Bid No. 19183

Addendum #2

Addendum #2 covers the adjustments made to the location of the fence-line, gate, and the expectations for the creek crossing since Addendum #1 was released.

Addendum #2 1-A

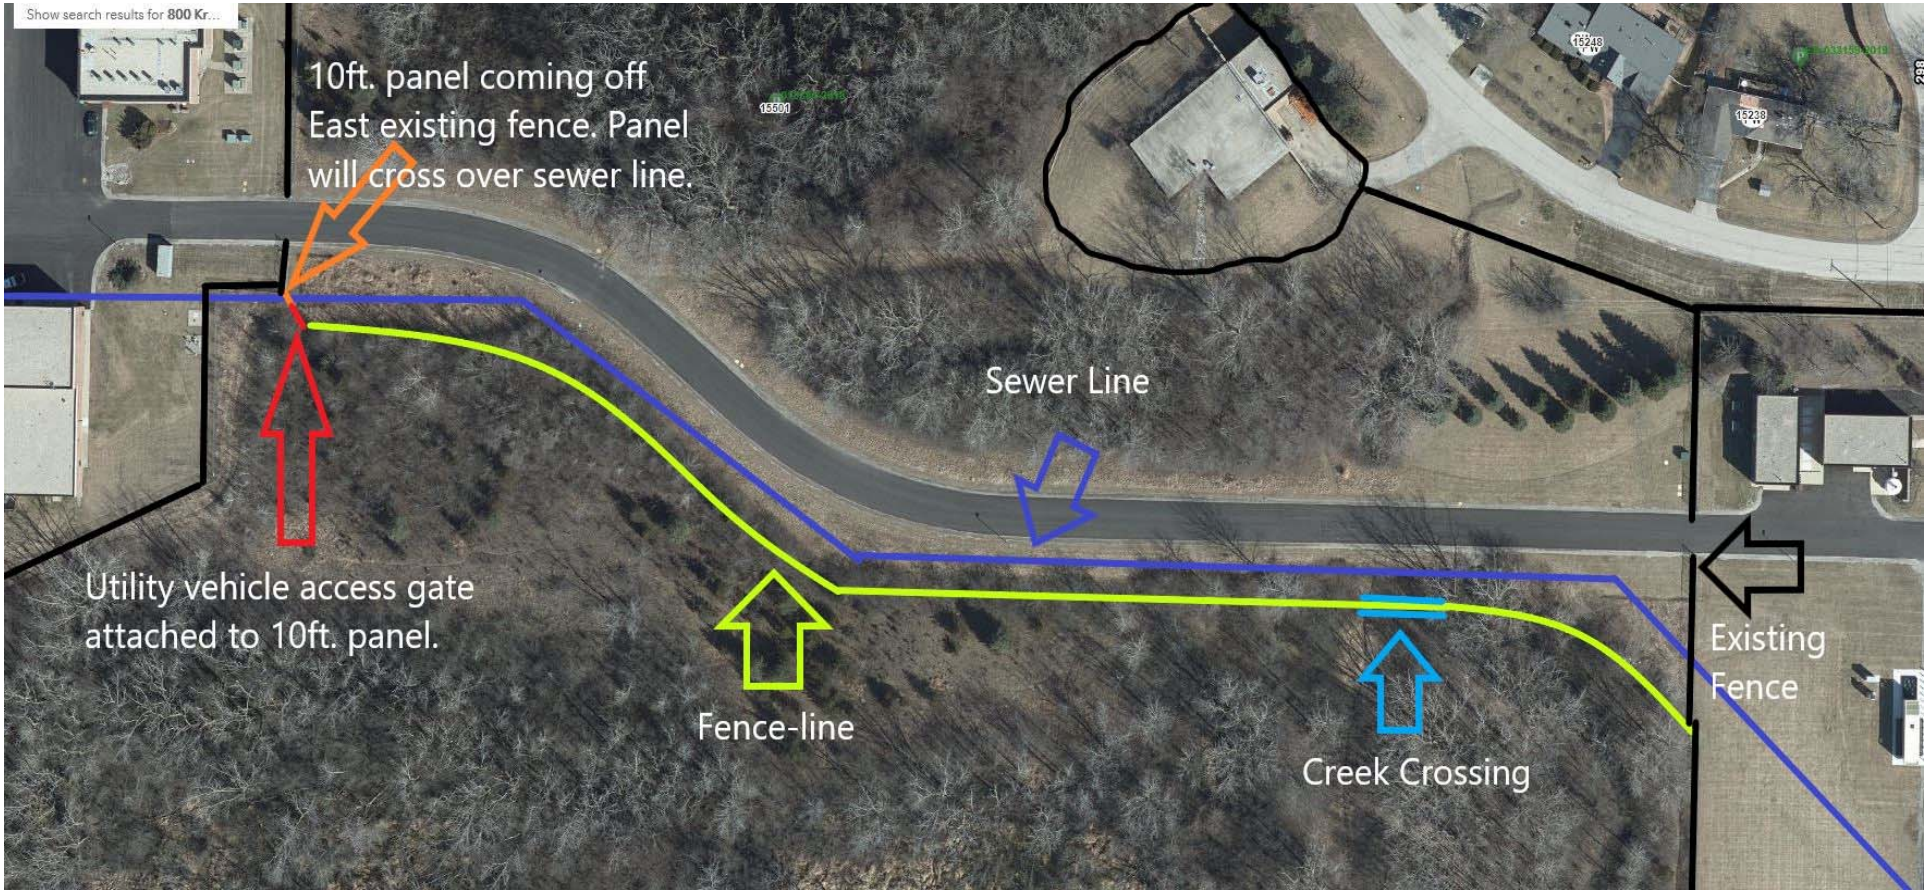
There is an underground sewer line that runs parallel approx. 10ft. in from the roadway. Additional brush was cleared by Lake County Public Works in order to push the fence-line in further south to avoid installation over the sewer line. The fence-line and sewer-line have been staked out for the installer to follow. Lake County Public Works will be responsible for keeping everything marked until work can be started in the Spring.

Please see Addendum #2 1-A drawing.

Please note the gate for the utility vehicles to pass through needs to be installed diagonal to the existing East fence. In order to avoid gate installation over the sewer line, there should be a 10ft. panel that is attached to the post connecting to the existing East fence. The gate should connect to this panels. See Addendum #2 1-A drawing.
